Form 3160-5  
(June 2019)UNITED STATES  
DEPARTMENT OF THE INTERIOR  
BUREAU OF LAND MANAGEMENTFORM APPROVED  
OMB No. 1004-0137  
Expires: October 31, 2021**SUNDRY NOTICES AND REPORTS ON WELLS**  
**Do not use this form for proposals to drill or to re-enter an abandoned well. Use Form 3160-3 (APD) for such proposals.**

Ruthless 11 Fed Com 728H (FKA 755H) API #: 30-025-51184

EOG respectfully requests an amendment to our approved APD for  
this well to reflect the following changes:

#### Revised Permit Information 02/02/2023:

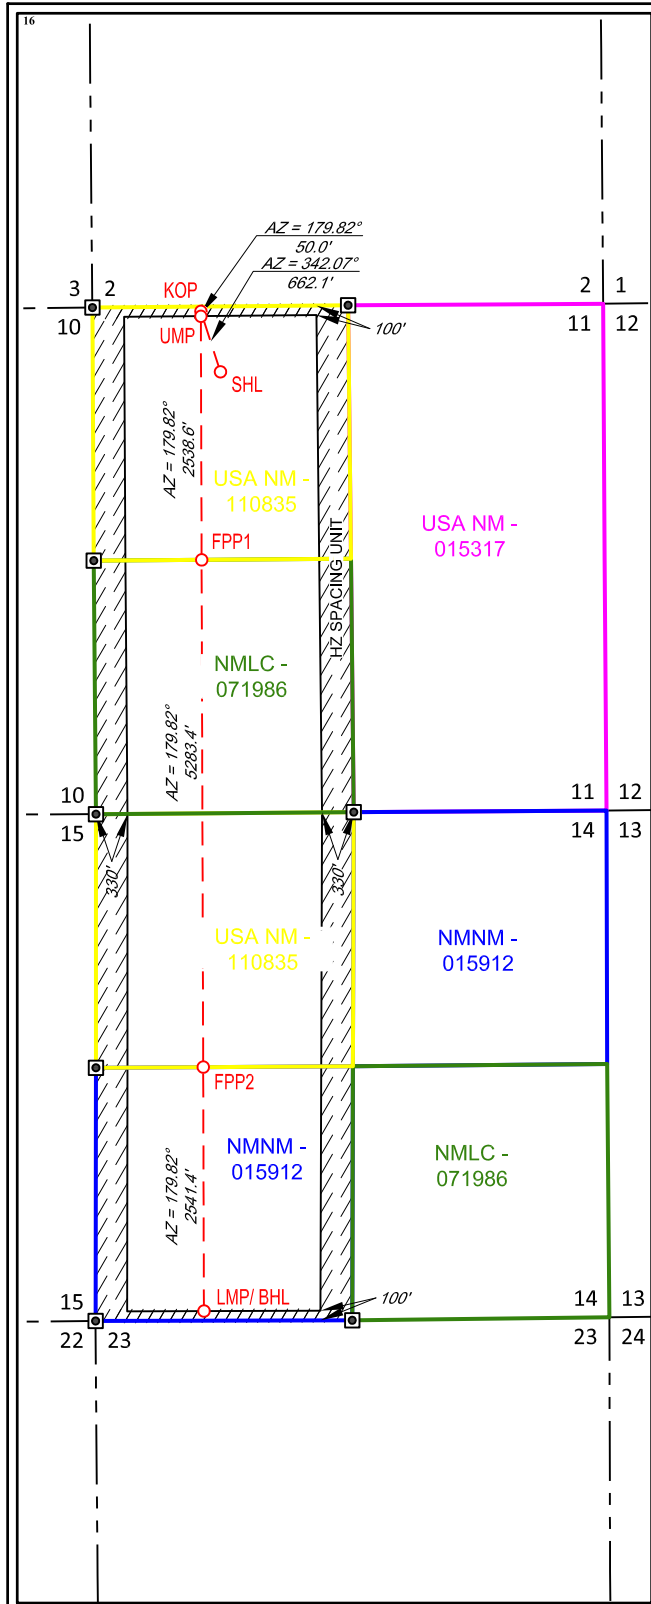
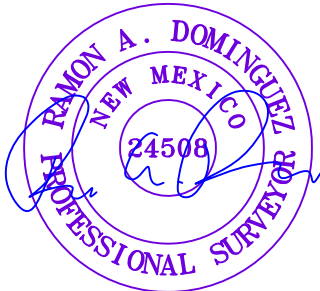
Change name from Ruthless 11 Fed Com 755H to Ruthless 11 Fed Com 728H.

Change BHL from T-25-S, R-32-E, Sec 14, 100' FSL, 1500' FWL, Lea Co., NM,  
to T-25-S, R-32-E, Sec 14, 100' FSL, 1130' FWL, Lea Co., N.M.

Change target formation to Wolfcamp U2.

UL or lot no.	Section	Township	Range	Lot Idn	Feet from the	North/South line	Feet from the	East/West line	County
M	14	25	32	—	100'	SOUTH	1130'	WEST	LEA

100' FSL - SEC. 14  
1130' FWL - SEC. 14  
X=752667 Y=409344  
LAT.: N 32.1235251  
LONG.: W 103.6506890
